United States Nuclear Regulatory Commission Official Hearing Exhibit		
In the Matter of: POWERTECH USA, INC. (Dewey-Burdock In Situ Uranium Recovery Facility)		
	ASLBP #: 10-898-02-MLA-BD01	Identified: 8/19/2014 Withdrawn: Stricken:
	Docket #: 04009075	
	Exhibit #: APP-016-C-00-BD01	
	Admitted: 8/19/2014	
	Rejected:	
Other:

Revised Responses to TR RAIs Dated May 28, 2010**Meteorology****TR RAI 2.5-1**

Figure TR RAI 2.7-2-1

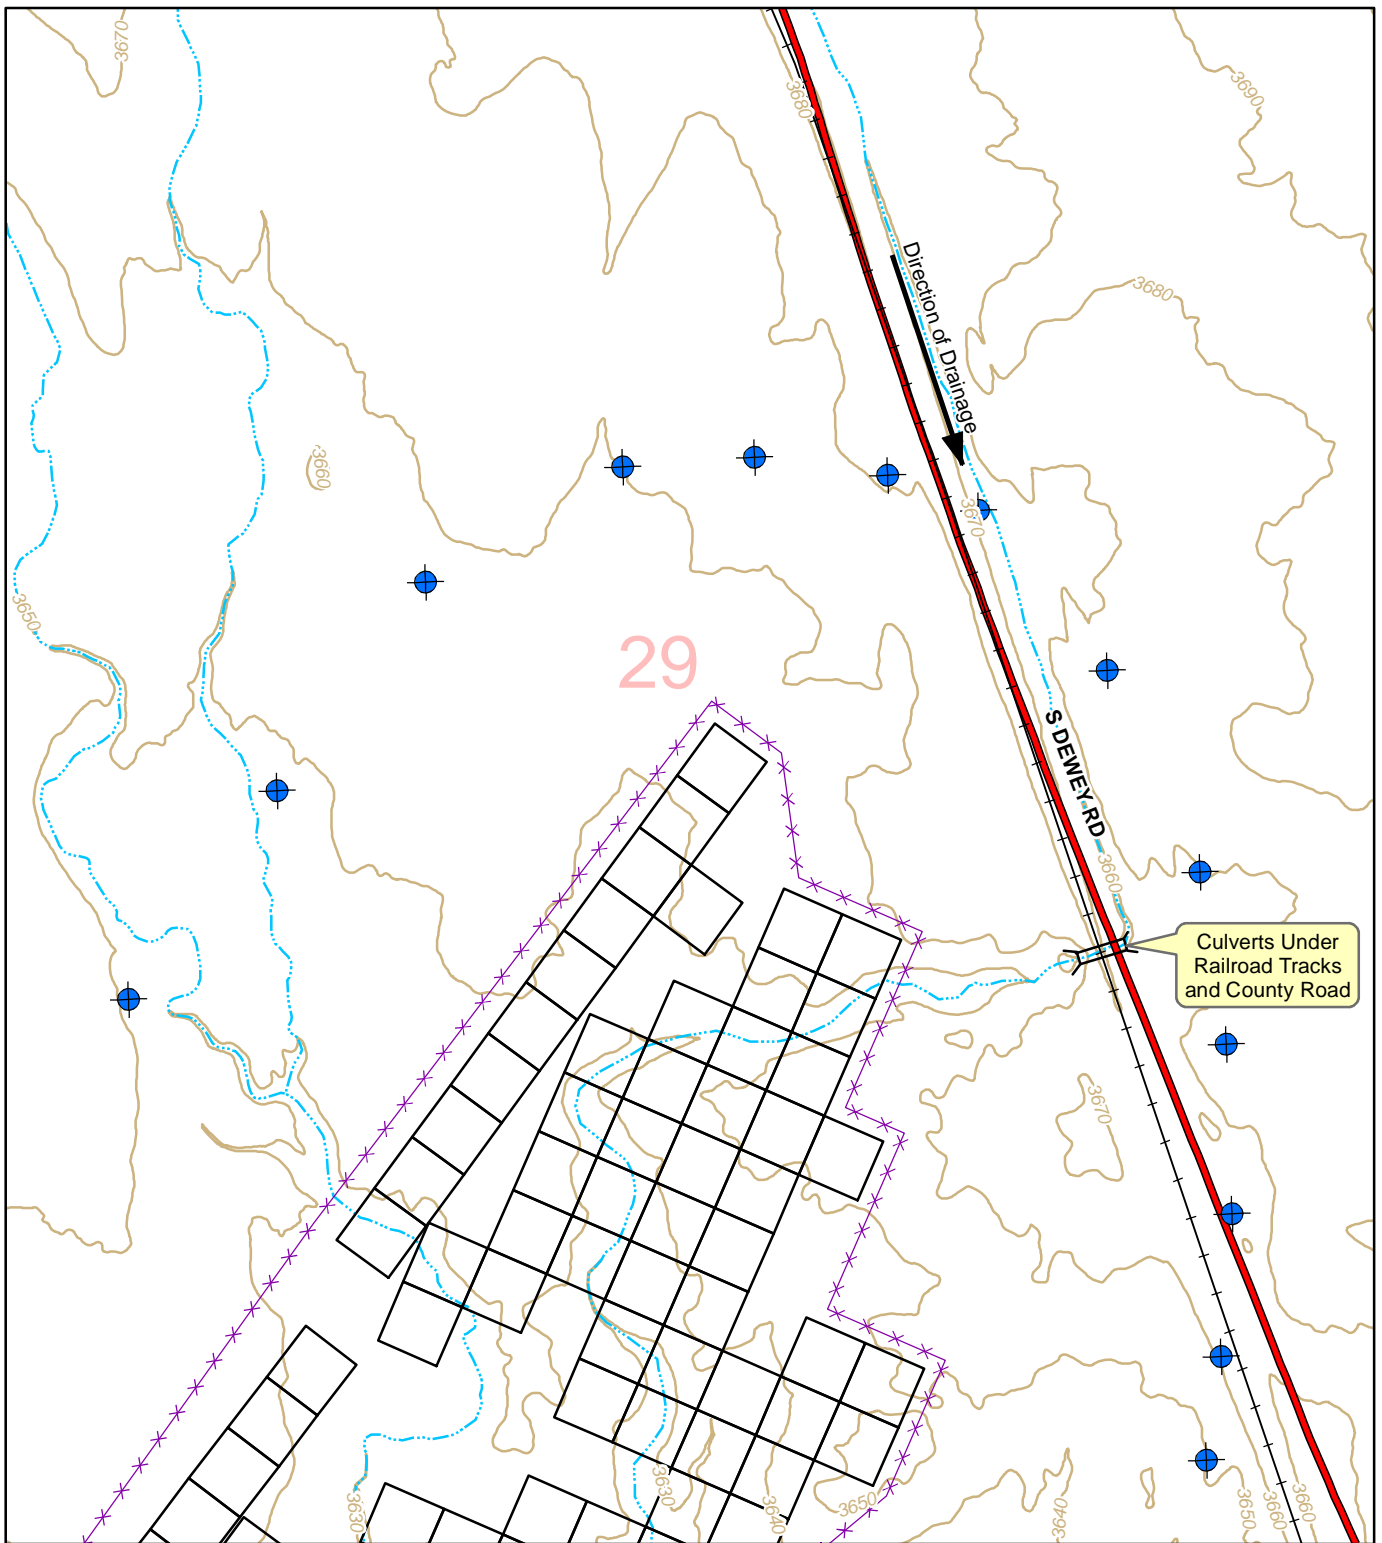
Exhibit 3.2-1 of the TR Supplement indicated that the horizontal excursion monitoring well ring for Dewey Well field #1 is traversed by a set of railroad tracks. Staff was uncertain of the surface drainage in the topographic low areas on the northeast side of the tracks and whether the construction of the tracks includes any type of drainage system you might see for a double track construction (i.e., surface and/or subsurface drainage system). Staff is uncertain if standing water in poorly drained areas will hamper access to wells and potentially facilitate well leakage. Please clarify the surface drainage of this area.

Figure TR RAI 2.7-2-1 depicts the northern portion of proposed Dewey Well Field 1 area where some of the perimeter monitor wells will likely be located across a railroad and county road from the well field. Powertech investigated the drainage in this area in May 2011 and determined that there are culverts beneath the county road and the railroad which will prevent ponding of water near the monitor wells. The railroad culverts consist of two 5' x 6' rectangular box culverts. One 18" corrugated metal pipe culvert provides drainage for the county road. Despite an unusually high amount of rainfall during May 2011, no ponded water was observed in this area. The monitor wells will be located outside of the drainage channel and will not be subject to flooding. Adequate access to the perimeter monitor wells will be available even during infrequent storm events that trigger ephemeral flow through the railroad and county road culverts.

Note that the potential well field and monitor well locations shown on Figure TR RAI 2.7-2-1 are only conceptual locations at this time. A revised, detailed design will be provided in a well field hydrogeologic data package.

Figure TR RAI 2.7-5-1

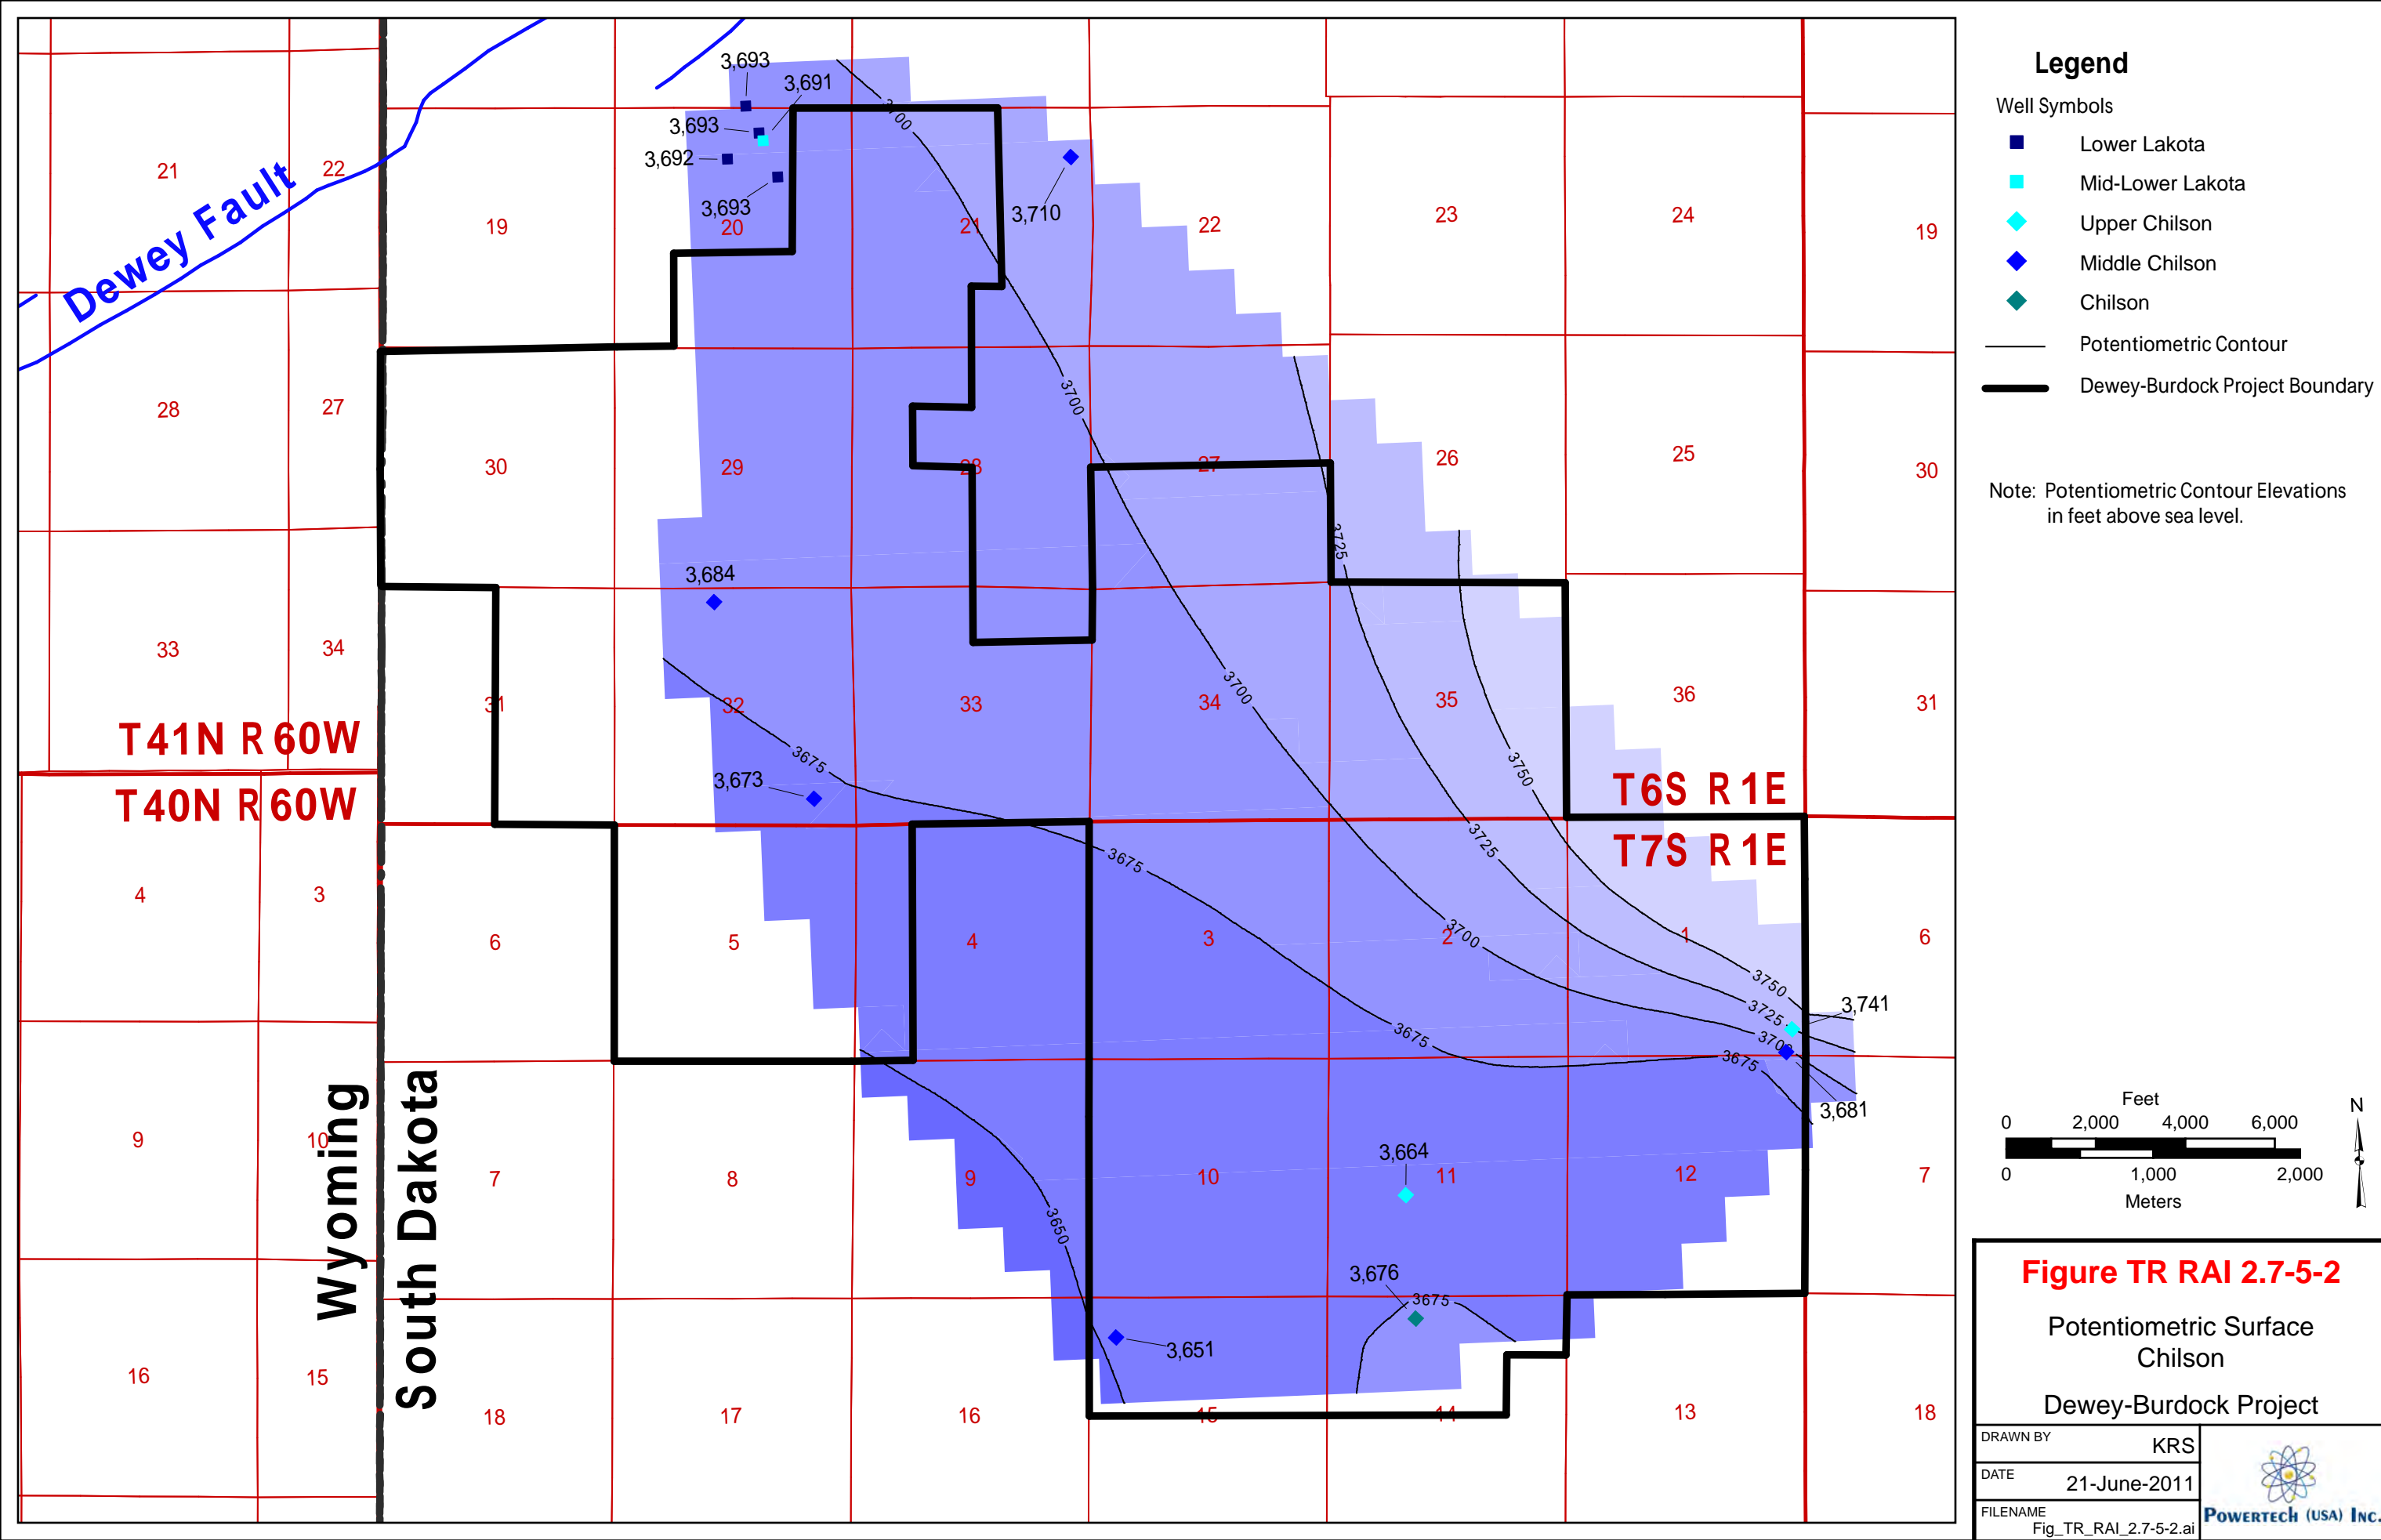
NRC Staff notes that the location of several of the potentiometric contour lines in Figures 2.7-14 and 2.7-15 of the TR conflicts with water level data posted at several of the well points. Please explain the cause of this error.

The potentiometric contour maps for the Fall River Formation and the Chilson Member of the Lakota have been revised and are presented as Figures TR RAI 2.7-5-1 and 2.7-5-2, respectively. The prior versions of these maps were prepared from water level measurements taken at different times over a several-year period, whereas the revised contour maps are based on water level measurements collected during a 5-day period, April 25 through April 29, 2011. The wells used in the development of the contour maps, their respective completion intervals, times of measurement and measured water level elevations will be included within the revised TR. The current set of potentiometric surface maps includes several additional monitoring points compared to previous mapping efforts, providing better data density for modeling the potentiometric surface. Additional details are provided in the response to TR RAI P&R-12(b).
